SUBJECT: Change of 0201 Multi-layer Thermistor (ERT-JZxxxxxxx) Packaging Specification

BULLETIN #: ECN.PG33.02.01.08-1

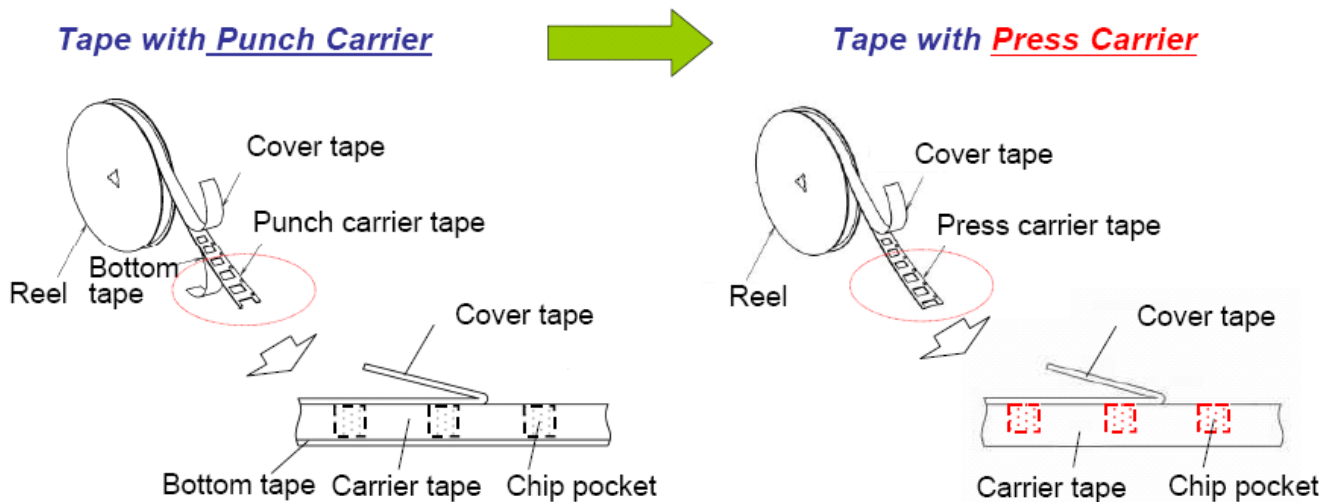
ENGINEERING CHANGE DETAILS: Punch Carrier tape to Press Carrier tape

REASON FOR CHANGE: To improve the 'picking' of 0201 parts from their taped reels and its mounting performance

2 main improvements:

- Reduces the occurrences of 'standing' or 'non pick-up' components due to the components sticking to the bottom tape
- The shape of the component 'pocket' is more consistent with regard to its dimensions and component clearances
